HISTORIC AND DESIGN REVIEW COMMISSION

HDRC CASE NO: 2017-580
ADDRESS: 1200 IOWA ST
LEGAL DESCRIPTION: NCB 3886 BLK 2 LOT 1
ZONING: RM-4 H
CITY COUNCIL DIST.: 2
DISTRICT: Knob Hill Historic District
TYPE OF WORK: Rehabilitation, window replacement
APPLICATION RECEIVED: November 2, 2017
60-DAY REVIEW: January 1, 2018
REQUEST:

Site Plan

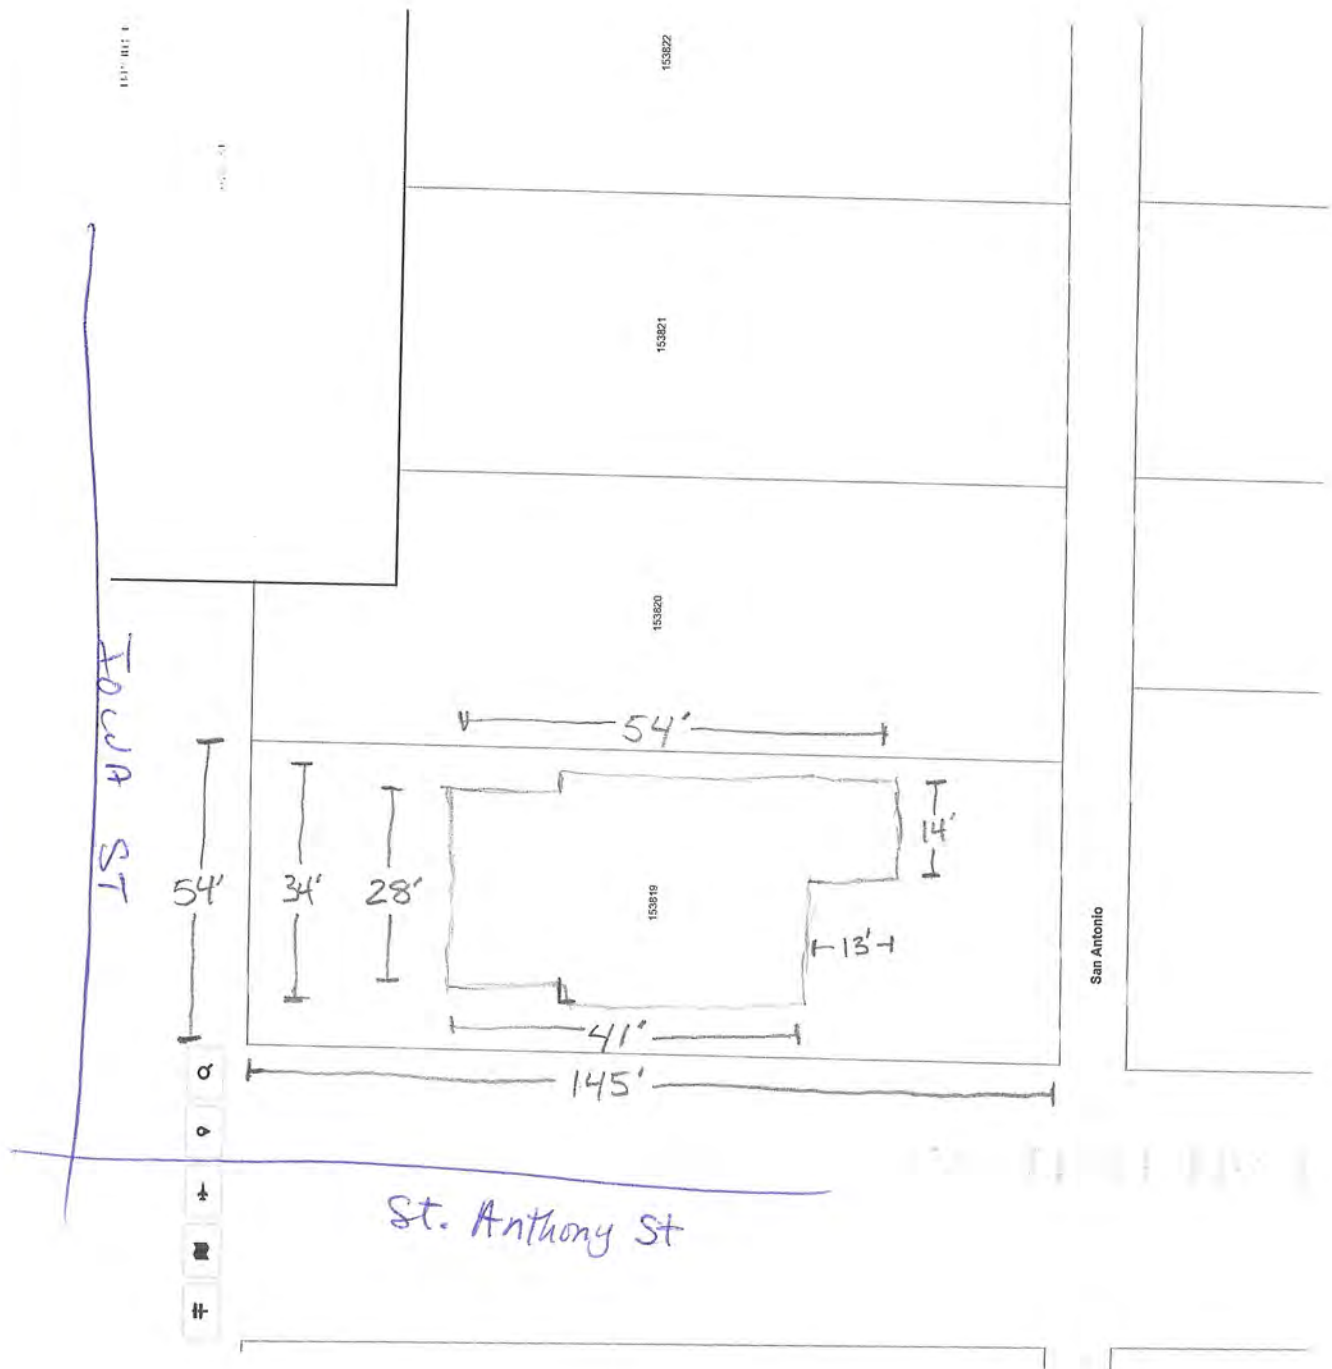
- b. **EXTERIOR ALTERATIONS** - The applicant has proposed to remove the two front doors to install a centered primary door, to relocate the existing window openings, and to relocate the existing columns. The applicant had already begun work by removing the left-side door, the left side windows, and all of the columns and their respective porch roofs, and partially installing new siding. The Guideline for Exterior Maintenance and Alterations explicitly prohibits major changes to historic façade configurations whenever preservation, replacement in-kind, or repair is possible. Staff finds the proposed front façade alterations for the mere intention of converting the duplex into a single-family structure highly inappropriate.

1. Staff does not recommend approval of the proposed reconfiguration of the front and rear façades based on findings b. Staff recommends that the original front porch elements be preserved in place.
